| .032 | TMC (Canada) LIMITED OTTAWA ONTARIO | | |
| AL ALY | PLATE - SHIELD | | |
| IRIDITE 5404 | | PM10113 X2 | |

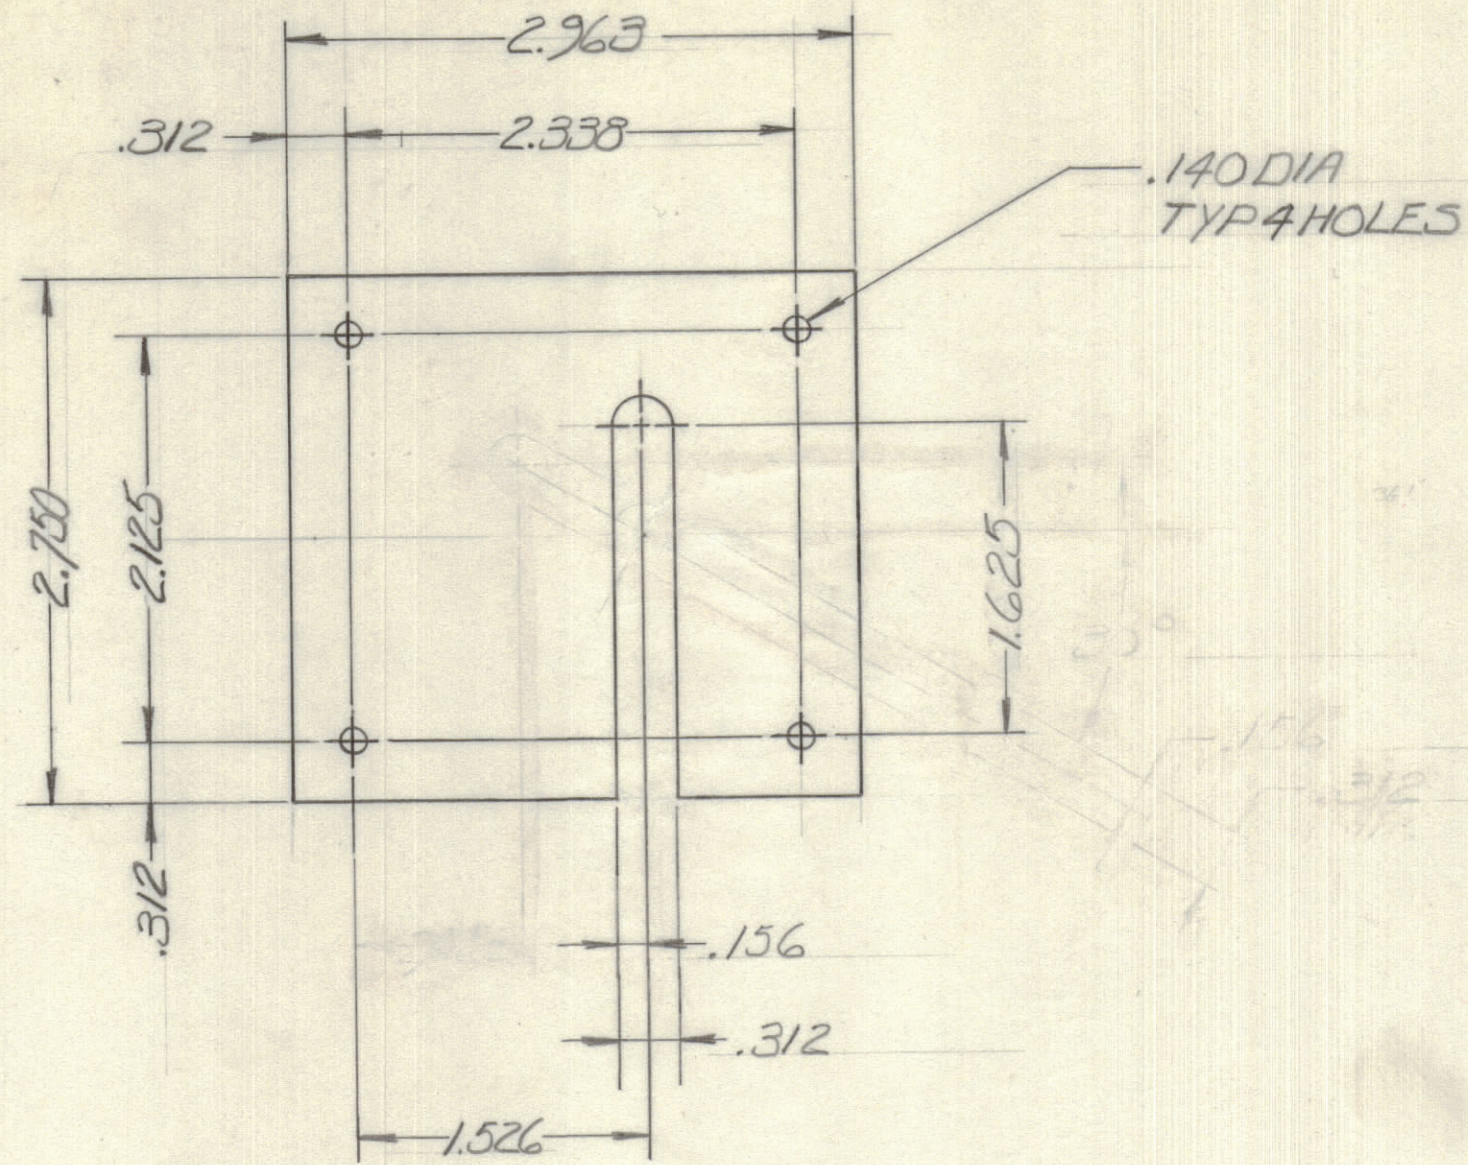
| IF IT IS FOUND DESIRABLE TO CHANGE ANY TOLERANCE OR OTHER DETAIL SPECIFIED ON THIS DRAWING NOTIFY THE PURCHASER PROMPTLY. | | | | DIMENSIONS IN INCHES UNLESS OTHERWISE SPECIFIED | | | |
|---|------|--|-----------|---|--------|---------|-----------|
| X1 | | .900 DIM WAS 1.526 1.424 DIM WAS 1.063 | 29 SEP 69 | | | FW | |
| X2 | | 1.526 DIM WAS .900 1.625 DIM WAS 1.424 30° ANGLE DELETED | 1 OCT 69 | | | FW | |
